B.G.A. TECHNICAL COMMITTEE

TECHNICAL NEWSHEET

TNS 7/8/89

PART 1 AIRWORTHINESS "AGGRO"

2. Check prior to each flight

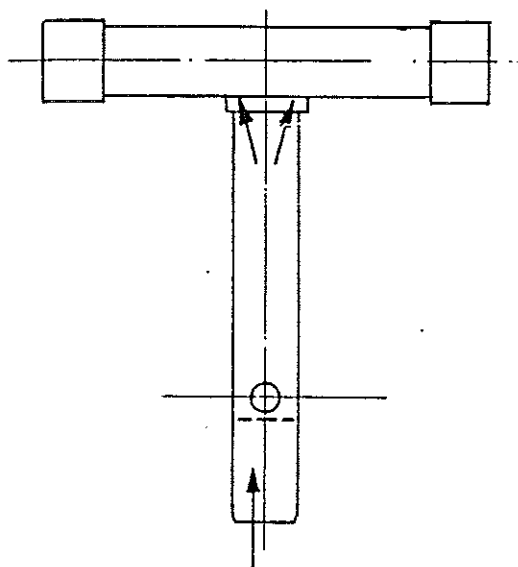
1b) Lift and pull down the tip of the all-
flying tailplane (aircraft rigged) with
ca. 150 N (33 lbs.) (see enclosure 2.).
If damage is detected no more flying is
allowed.

± 15 daN (33 lbs.)

no permanent deformation is allowed

3. Inspection of the welding

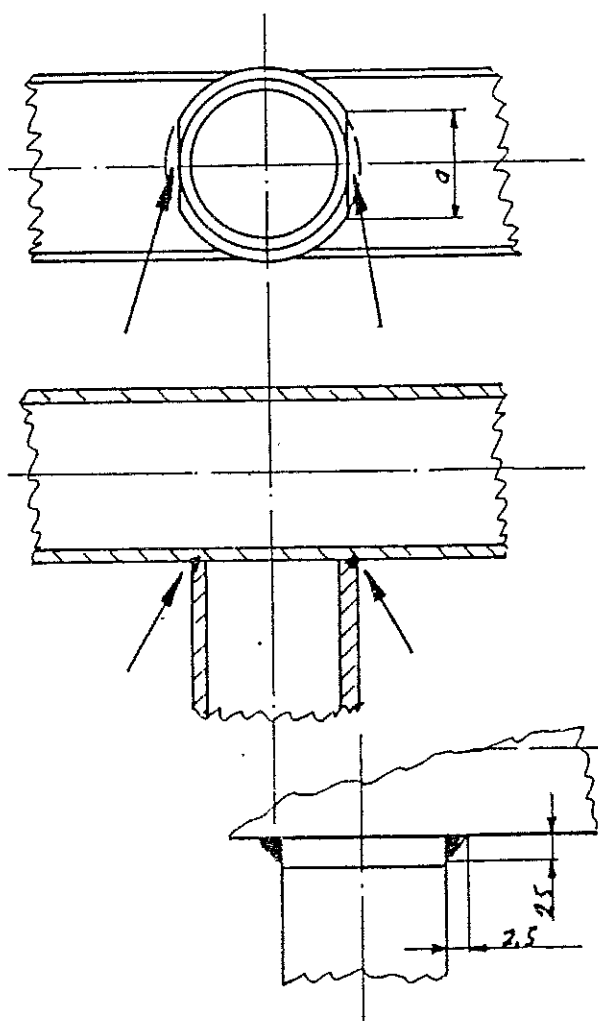
Inspect the welding in the edges
inside the tube by means of an Endos-
cope or an other suitable method.

This welding must be visible inside
the tube.

4. Repair of the fitting L 4

- a. file off part of the stopring each side
- b. weld the fitting in the region "a". Therefore cover the structure of the tailplane with sheetmetal parts to protect it against heat.
- c. check again see 3. if the welding is correct and visible from the inside of the tube.
- d. the missing part of the stop ring must not be replaced.
- e. preserve the inside of the tube with a suitable protecting agent for hollow spaces.

Thickness of welding 2,5 mm (0.1 in.)

Welding method for 4 b):
Method WIG (Wolfram Inert Gas)
TIG (Tungsten Inert Gas)
Welding wire 1.7734.2

MODIFICATION TO THE AIRBRAKES OF THE SCHLEICHER K7

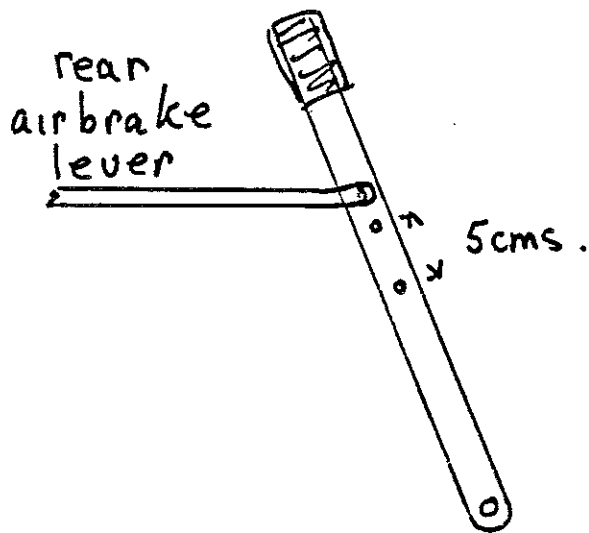
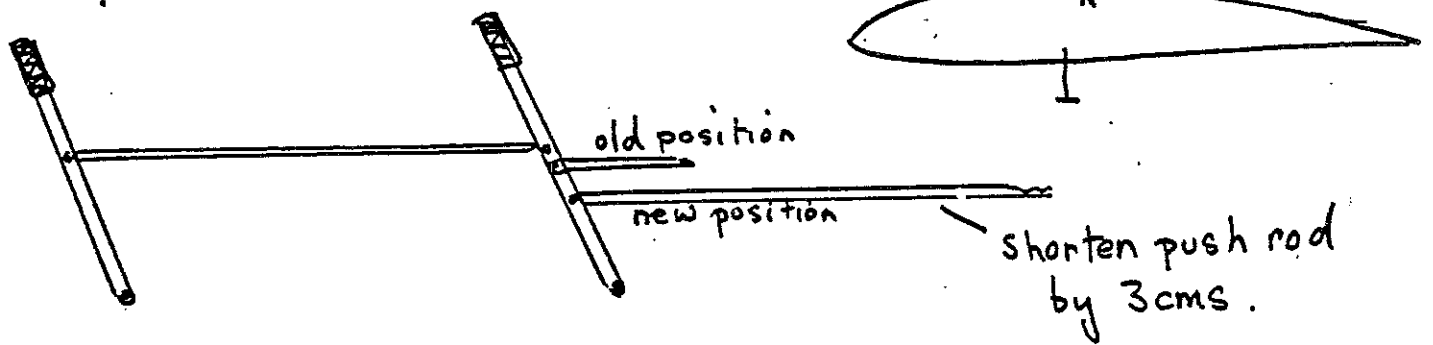
The airbrakes of the standard K7 are exceptionally powerful when compared with other similar types of glider. In addition the suck open loads are very high making it difficult for many pilots to operate the airbrakes smoothly and to reduce or close them unless the speed is very low. There is therefore a danger that if the speed is allowed to increase on an approach some pilots might not be able to avoid an undershoot because they are not strong enough to close the airbrakes.

The rear cockpit airbrake lever is disconnected and removed and redrilled inches below the bottom hole. The actuating rod from that lever to behind the rear seat is removed and cut and re-welded to reduce the overall length by xxx inches. When re-assembled into the new hole the cockpit levers should be in their original position when the airbrakes are close and locked.

The fully open position becomes with the top blade inches above the wing surface.

Remove push rod, redrill rear cockpit airbrake lever 5cms. down. Cut, shorten and re weld push rod by 3cms. to re position lever as before. Readjust 'stop' on push rod.
